*Installation of New Breaker for Ferroresonance Control at Riverdale TS –
Notification of Approval of Connection Proposal - CAA ID Number: 2005-EX212*

*Installation of 115 kV Breaker for Ferroresonance
Control at Riverdale TS*

CAA ID 2005-EX212

Final Report

Figure 1: Proposed changes at Ottawa Riverdale TS

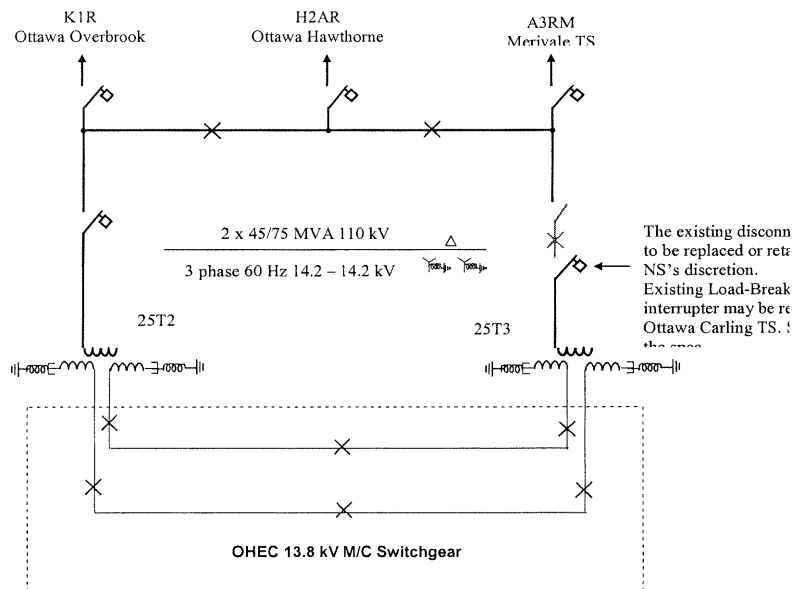
The interrupting current capability of the new breaker is below the value of 50 kA, recommended in the Transmission System Code. However, with a rated interrupting capability of 40 kA, the proposed breaker has a comfortable interrupting margin when compared with the maximum 3ph fault current of 17.8 kA, calculated by Hydro One for 2004.

In the future, if system conditions change in the area and the short circuit levels increase beyond 40 kA, Hydro One will be required to upgrade the breaker whose installation is proposed in this project.
